# Tronox LLC Henderson Facility Fact Sheet

Re: **Tronox LLC (TRX)**  
**NDEP Facility ID #H-000539**  
Nevada Division of Environmental Protection (NDEP) Response to:  
*Appendix E -Data Validation Summary Report (DVSR) Annual Remedial Performance Report for Chromium and Perchlorate*  
Dated December 18, 2008

**PHASE B SOURCE AREA INVESTIGATION  
REVISIONS TO AREA I THROUGH IV WORK PLANS  
DRAFT TEXT/Drawing SUBMITTAL – NOVEMBER 10, 2008**

Fig 2-2 CS M

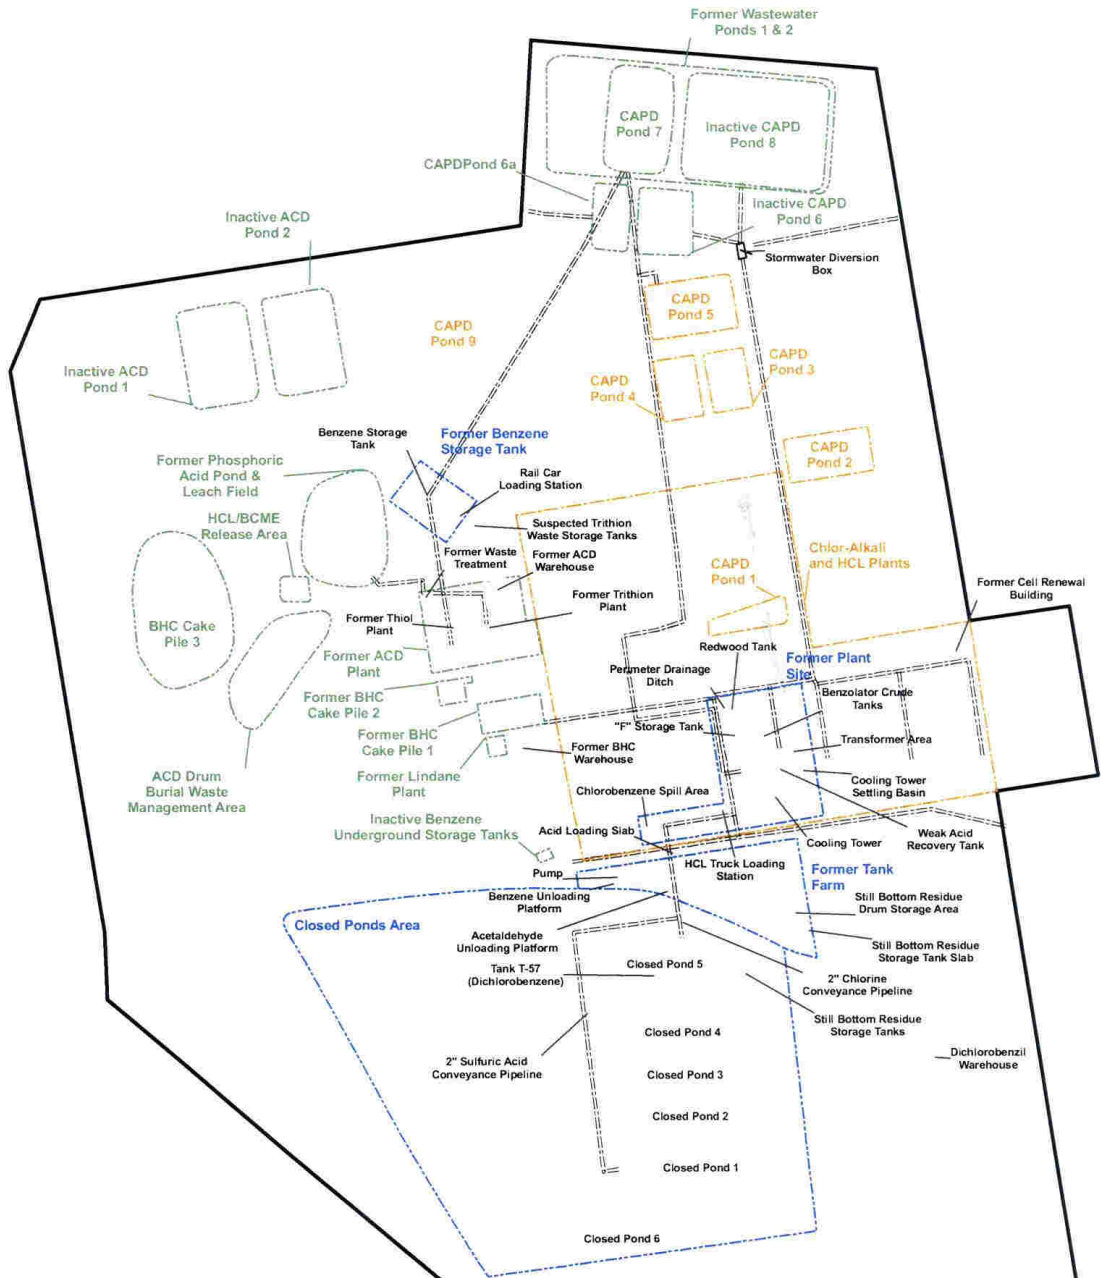
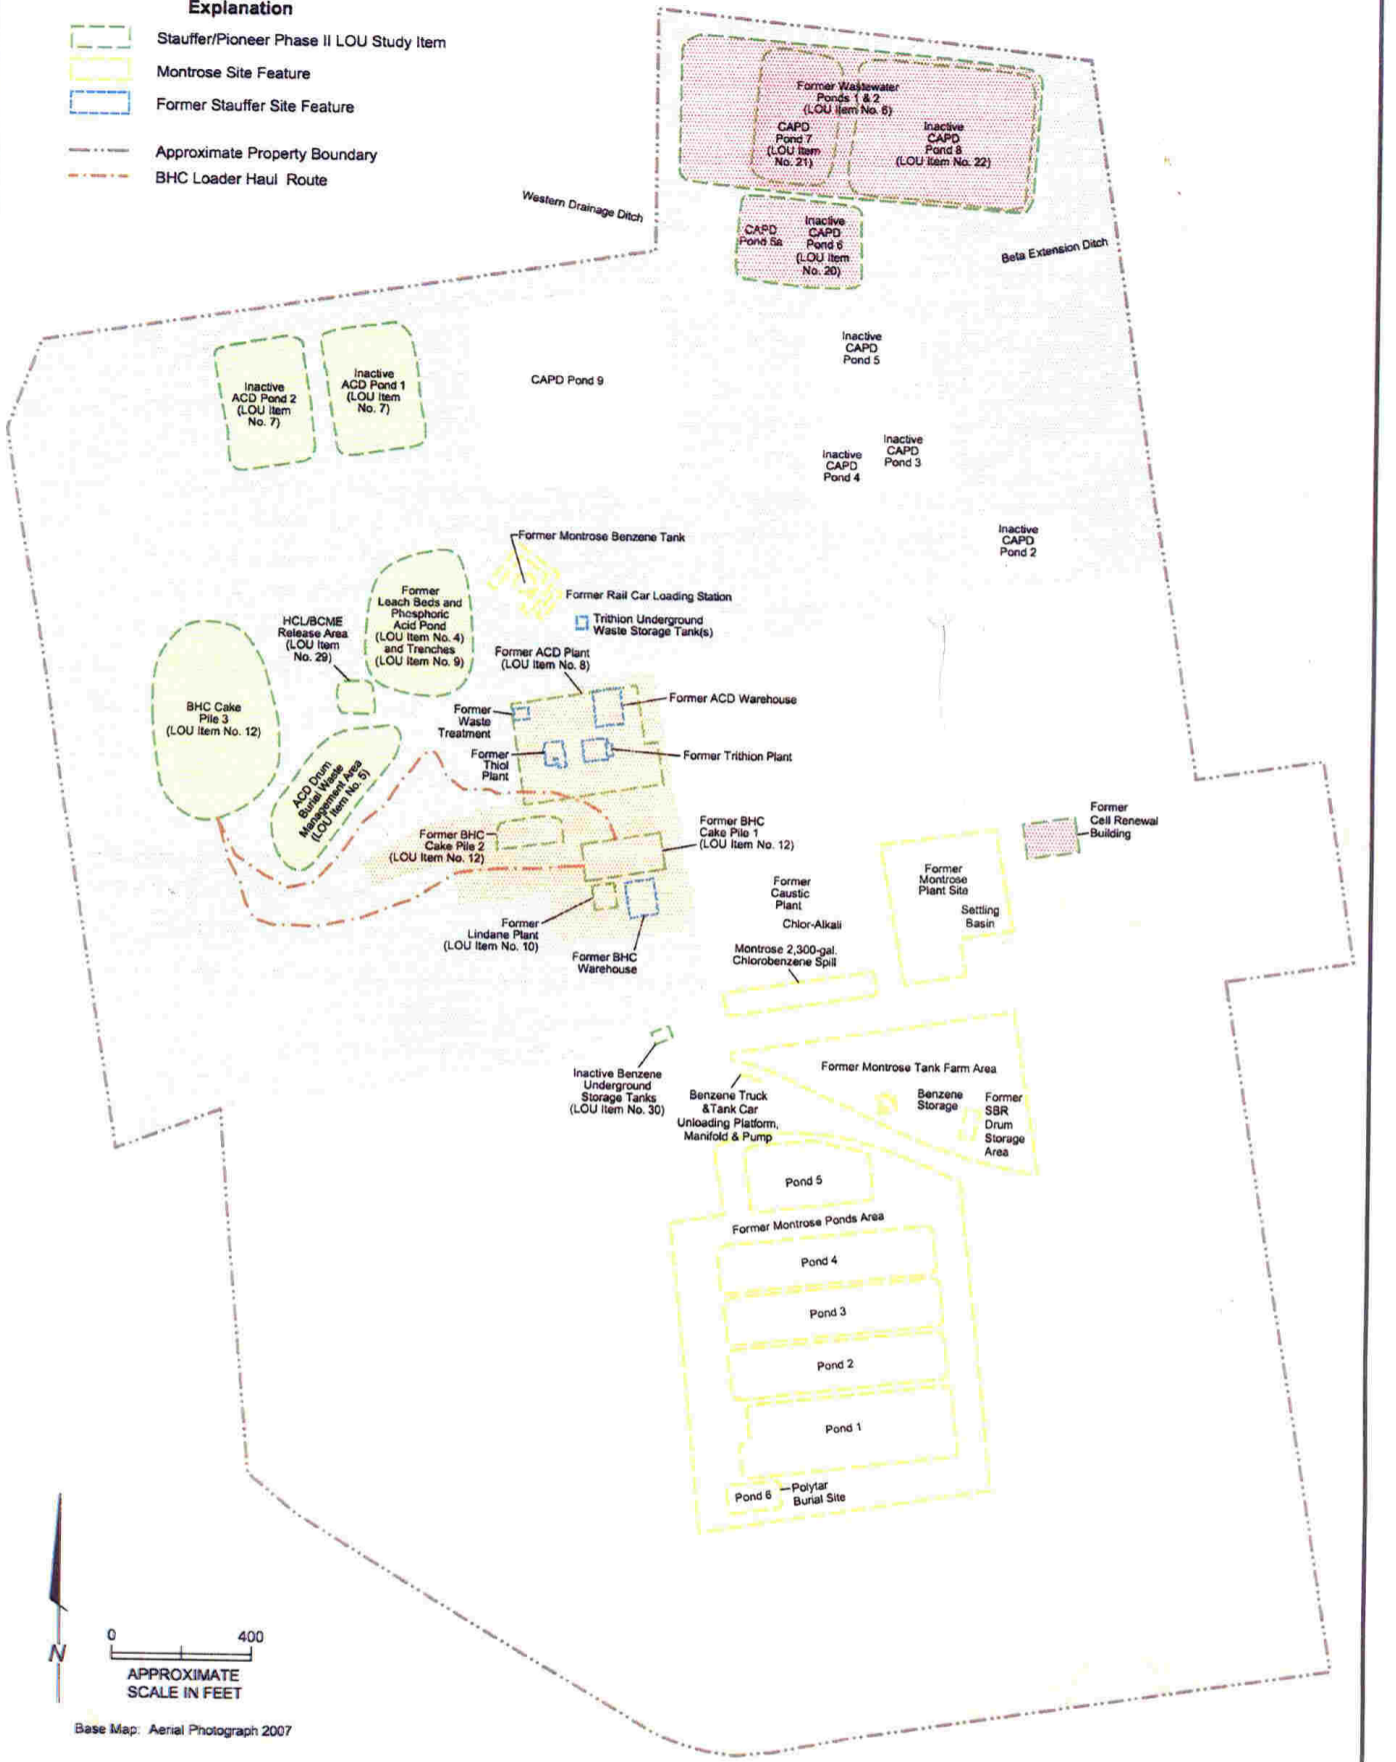
Based on information provided to Tronox by NDEP (Figure 2-2 of Revision 1.0 Conceptual Site Model, Former Montrose and Stauffer Facilities and Downgradient Areas to Las Vegas Wash, Henderson, Clark County, Nevada, Replacement Pages dated July 25, 2008), the only direct connections for the transfer of liquids potentially containing OPPs and OAs from the west are through the segment of LOU 60 that enters the Tronox Site at Grid O-2 and through off-site flow from the west onto the Tronox portion of the Beta Ditch. Accordingly, Tronox proposes to sample for OPPs and OAs in the specified segment of LOU 60.

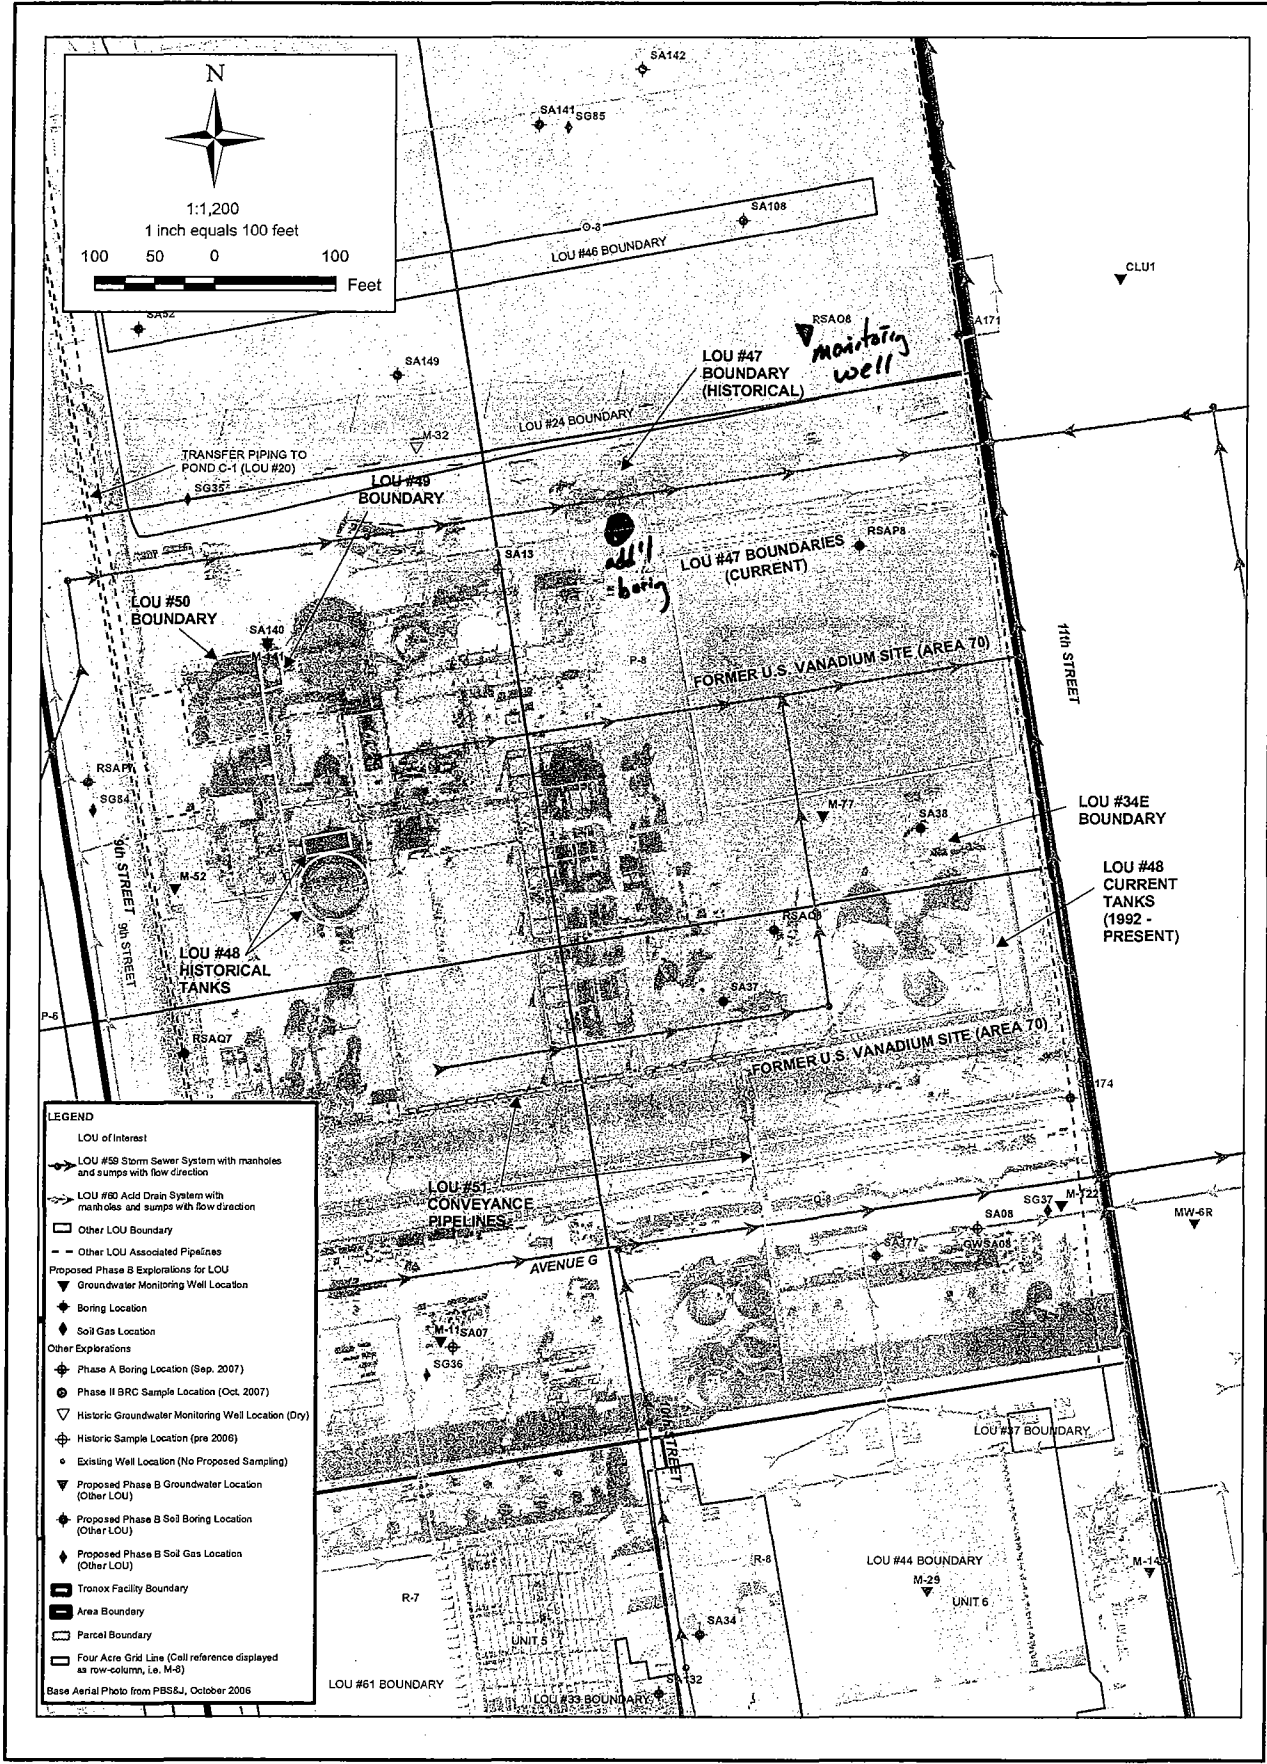
Additional boring on LOU 60 in northern portion of historical LOU 47.  
 Convert RSA08 to monitoring well.

SHEET NUMBER:	X
FIGURE NUMBER:	1

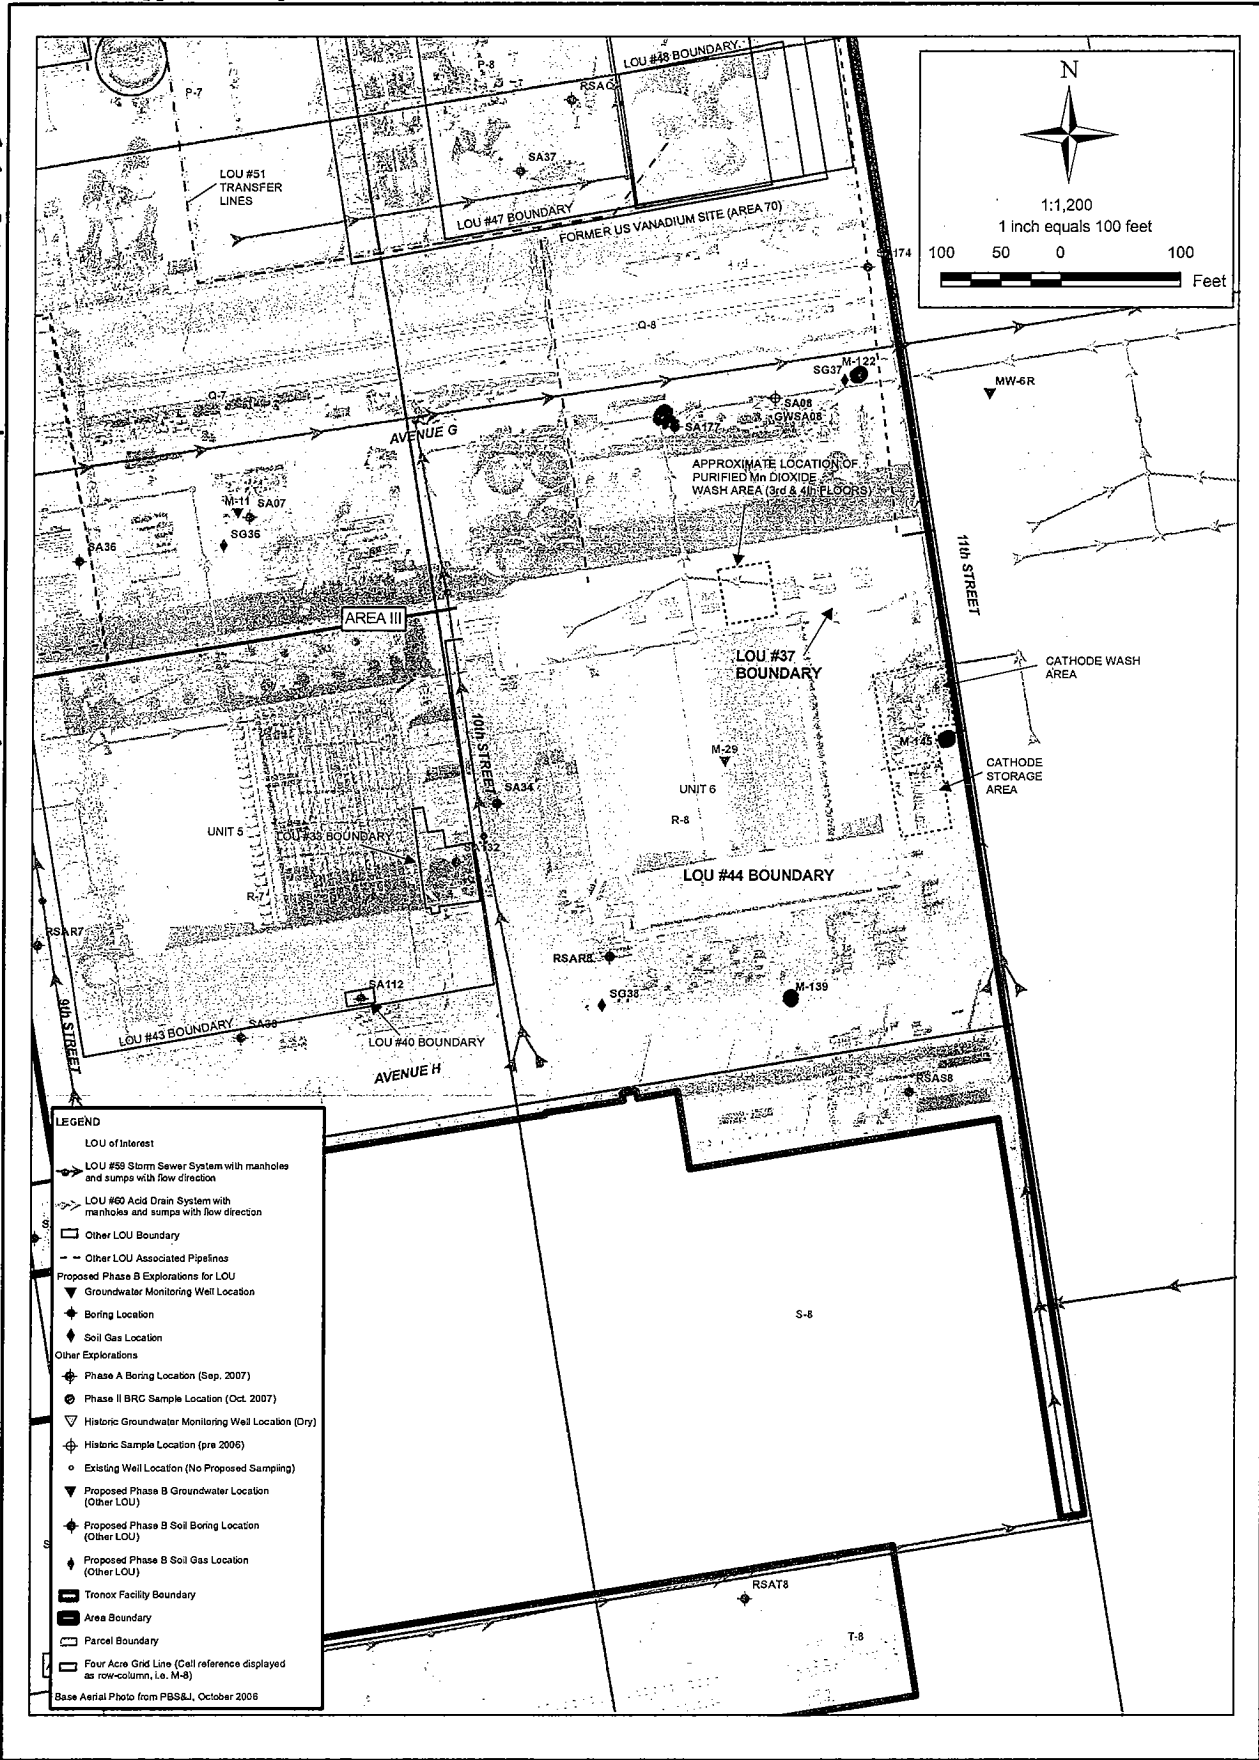
SA177 move to intersection/junction LOU 60.  
 Add borings (collect samples) for M-122, M-145 & M-139

SHEET NUMBER: X	FIGURE NUMBER: 1
--------------------	---------------------

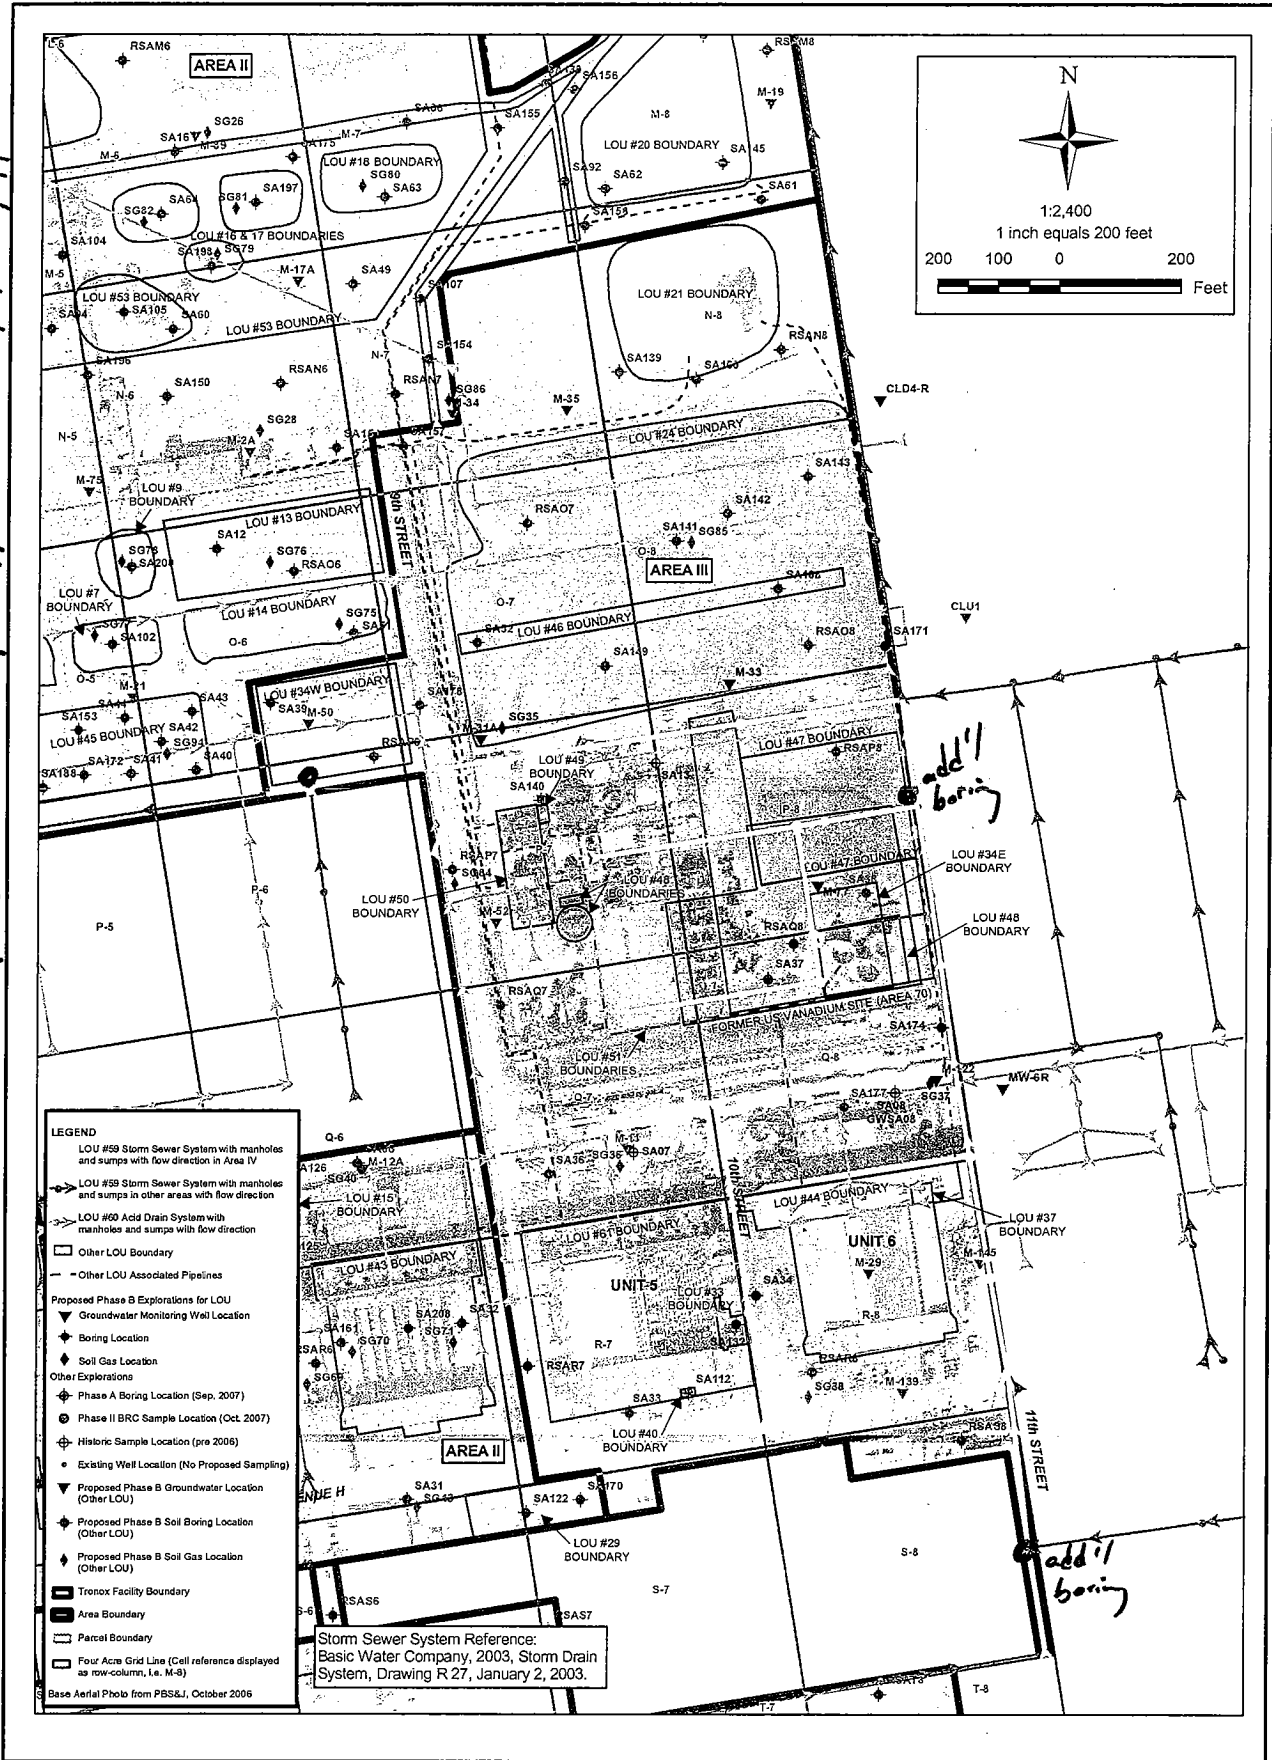
additional boring southeast portion of LOU  
 additional boring at junction on east side of LOU #7.  
 11.1.11  
 add 11 boring
